Subject: Phase A – Aleutian Islands Risk Assessment
Final Task 1 and Task 2 Reports Submittal Package

Resolutions/Response to Report Comments Tables
Task 1 Semi-quantitative Traffic Study Report
Task 2A Marine Spill Frequency and Size Study Report
Task 2B Baseline Spill Study Report

Attachment A
Response/Resolution to Report
Comments Tables

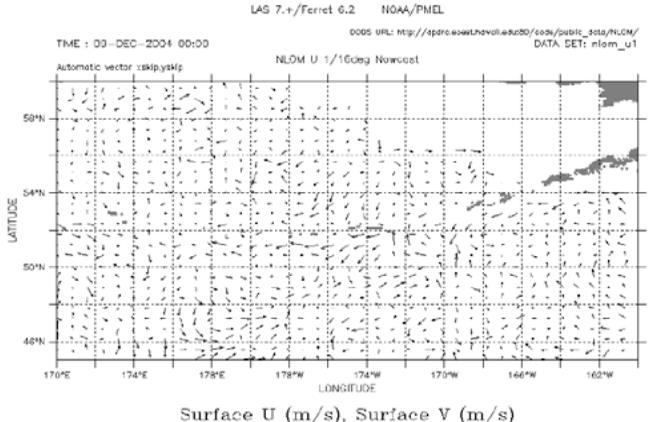
| SECTION/ Number | PRP COMMENT | RAT Category | Estimated Budget | MT Decision | RAT Actions |
|---|---|---|---------------------|---|---|
| | <p>Figure 4-18 Currents on Dec 8, 2004 few hours after the incident of Selendang Ayu spill</p>  <p>LAG 7.1/Ferret 6.2 NOAA/PMEL TIME: 03-DEC-2004 00:00 DATA SET: nlo_m_u1 Automatic vector skip:yskip NLOM U 1/16deg Nambuvel Surface U (m/s), Surface V (m/s)</p> | | | | |
